Town of Surfside

RFQ 2022-05

Construction of Town of Surfside 96th Street Park

Addendum No. 4

SHEET A-1.0

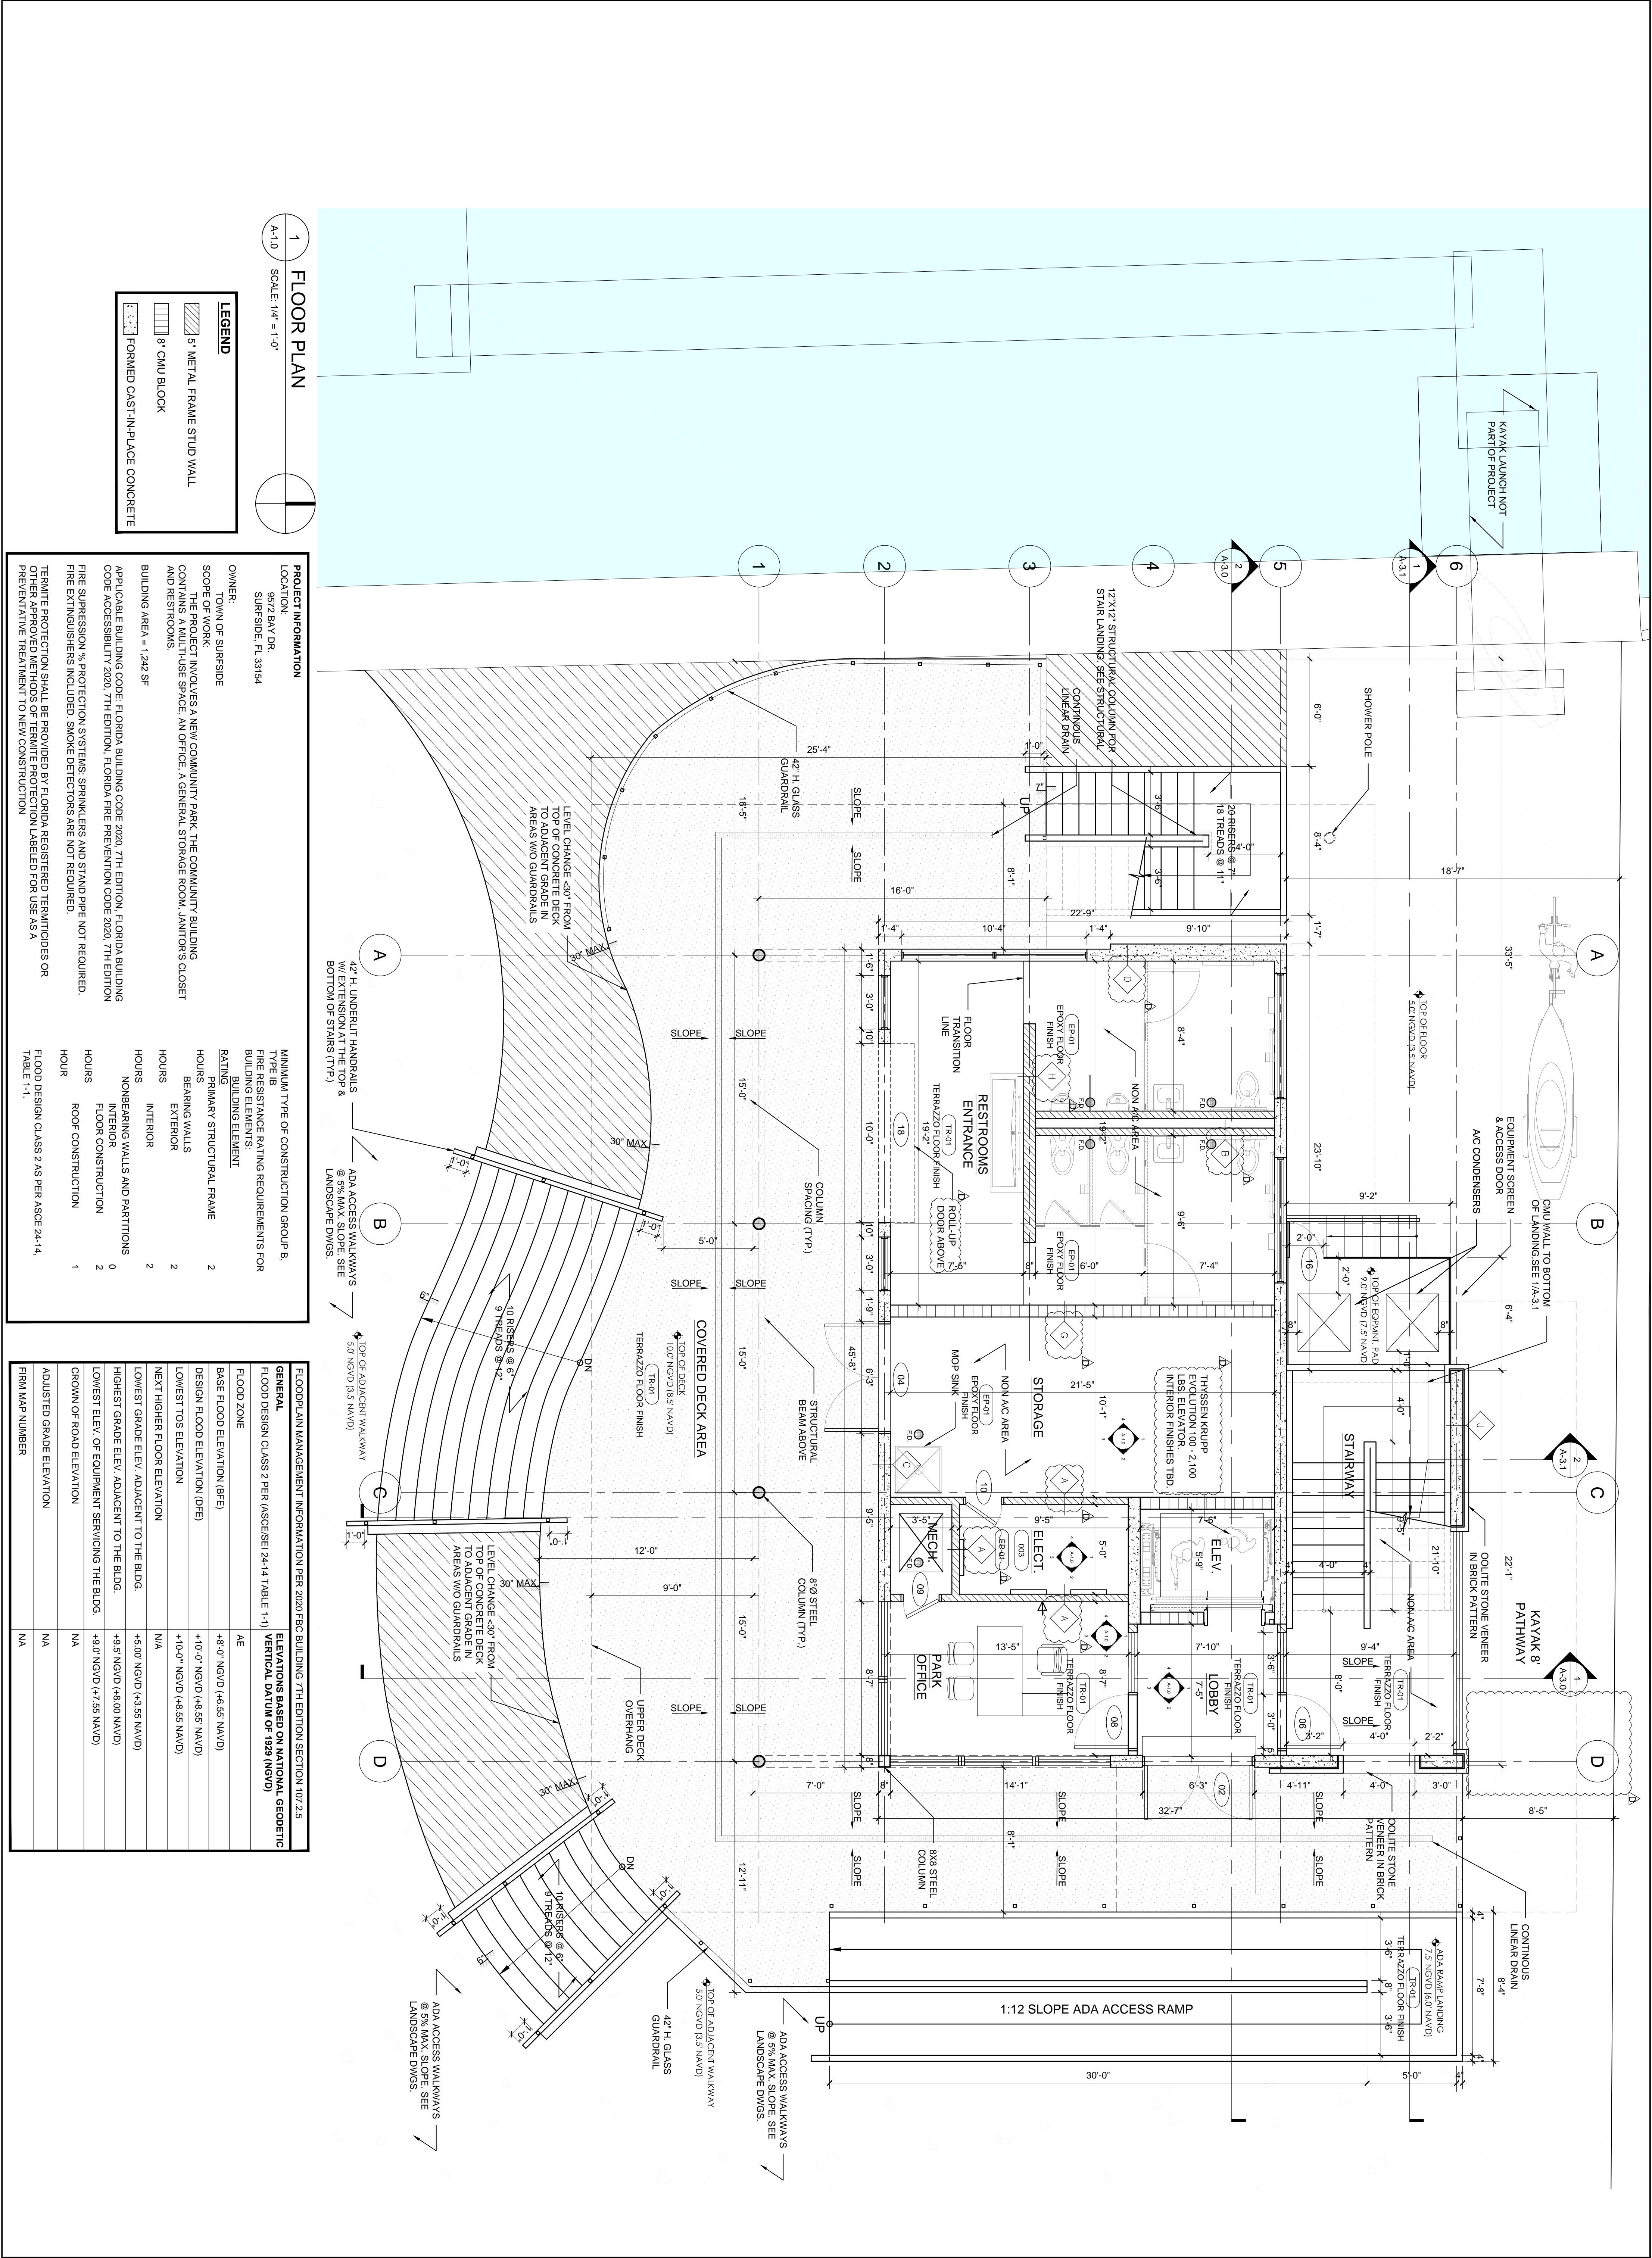
17. Sheet A-1.0: Kayak launch noted as “NOT PART OF PROJECT”, however details are provided for Kayak Launch within Landscape Set. Please confirm Kayak Launch is to be excluded from pricing.

- 38. Floor plan, sheet A-1.0 depict a screen around the a/c equipment. Please provide specifications/details/finishes.**

39. Floor Plan, sheet A-1.0 denotes an access door (door 16) at the a/c screen enclosure, while the Door Schedule on Sheet A-6.0 is specifying door 16 as an impact rated wood door on a metal door frame, receiving Hardware set. Please clarify.

42. Door tag #11 is used at the door into the Second Floor Restroom and at the First Floor Kayak Gate. Please clarify.

Kayak launch IS part of the project and is to be included in pricing.

A/C screen equipment details and elevations added on sheet A-4.3.

Door #16 on the schedule on sheet A-6.0 has been updated to describe the aluminum louvered vent gate for the a/c enclosure.

Door #11 on the schedule on sheet A-6.0 provides the description for the 2nd floor restroom door. The kayak area gate tag has been removed from sheet A-1.0. Refer to question #31 for kayak gate specifications.

1 SECOND FLOOR PLAN
 A-1.1 SCALE: 1/4" = 1'-0"

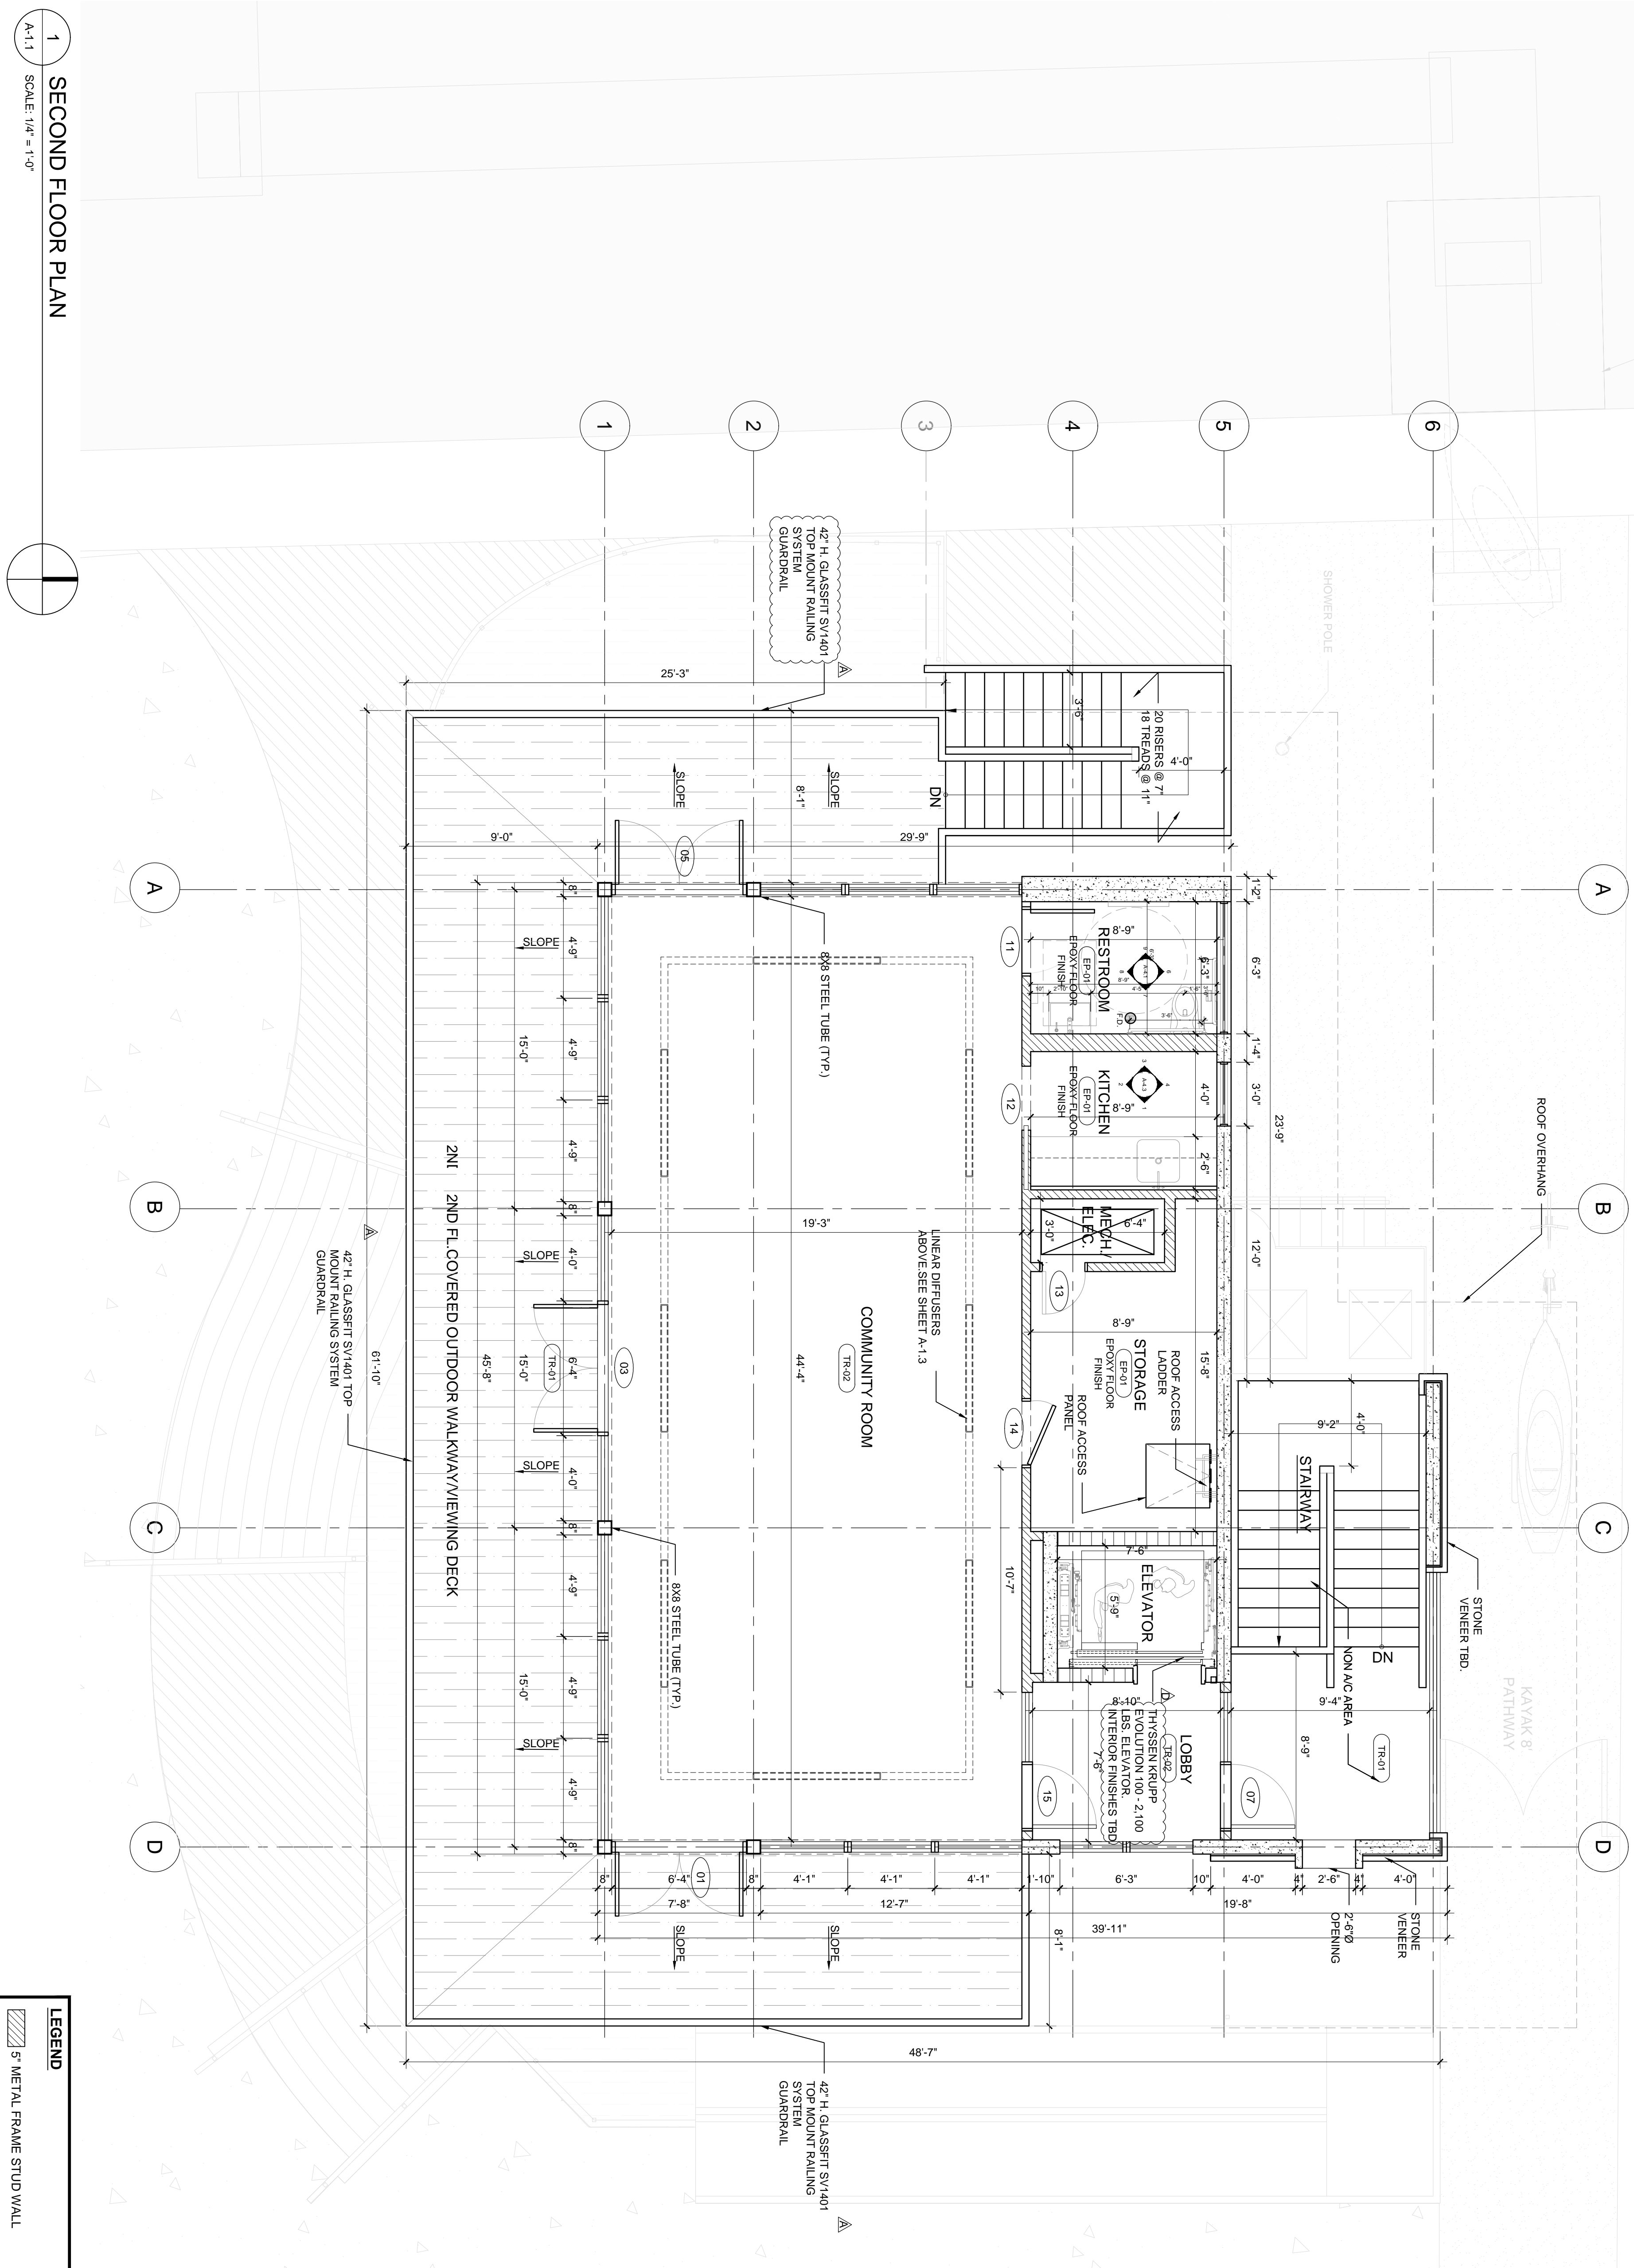
44. Second Floor Plan Sheet A-1.1 is specifying “Glassfit SV1401” glass railing system. Can we provide an equal CR Laurence glass railing system? Note that Glassfit is a European system.

Proposed alternates are to be provided for review and approval by the AE team.
